CITY OF LINCOLN/LANCASTER COUNTY PLANNING STAFF REPORT

P.A.S.: Final Plat No. 02029
Stone Bridge Creek 1st Addition

STONE BRIDGE CREEK 1ST ADDITION

FINAL PLAT

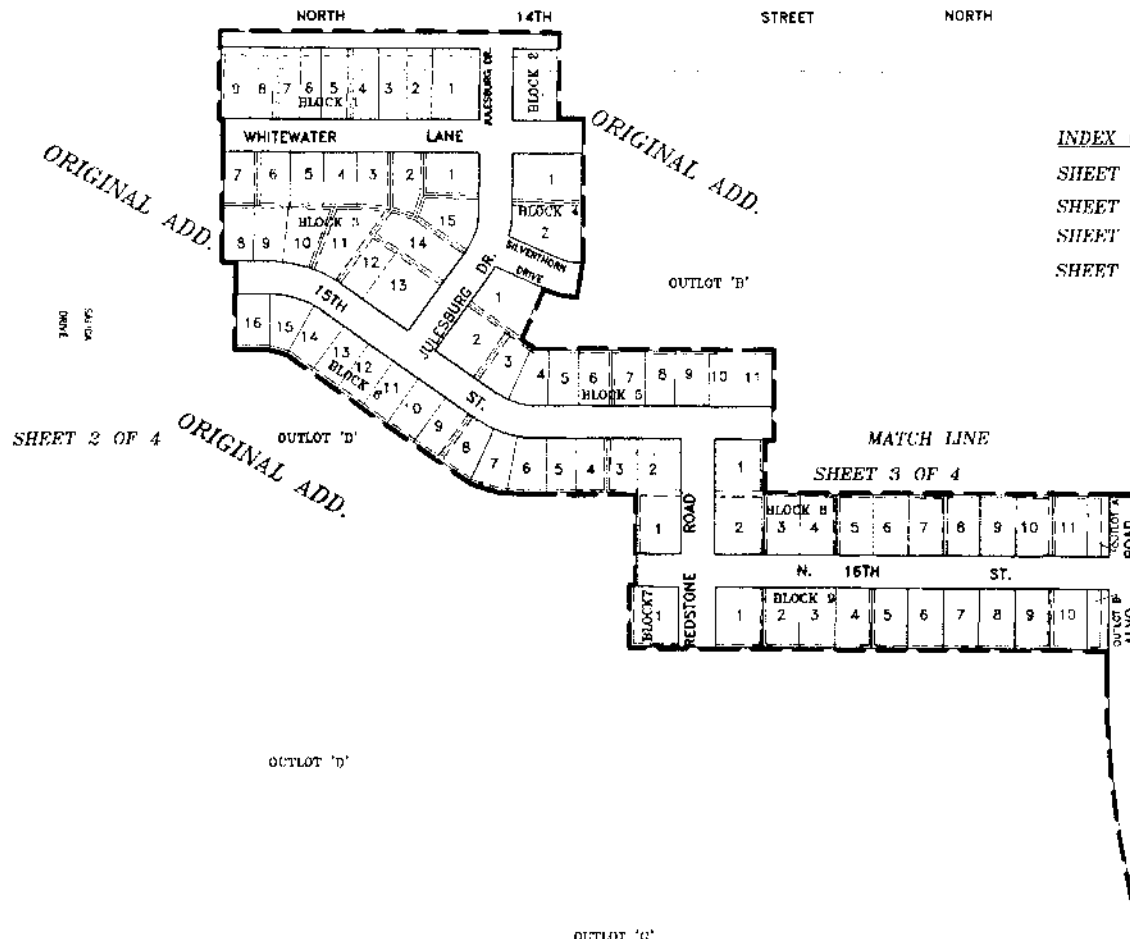
OCT. 25, 2002 BLB & SST - TANGENT LENGTHS FOR CURVES D & H ARE INCORRECT.

- SEVERAL ERRORS IN SURVEYOR'S CERTIFICATE
- SURVEYOR'S CERTIFICATE CLOSES BUT THE DRAWING DOES NOT.
- REMOVE "TO BE" FROM RIGHT-OF-WAY DEDICATION
- ADD DIMENSION TO OUTLOT 'B'
- BEARING ALONG NORTH SIDE OF PLOT SHOULD BE N & W, NOT S & E
- CURVE DATA FOR WAYE ALONG ALNO RD
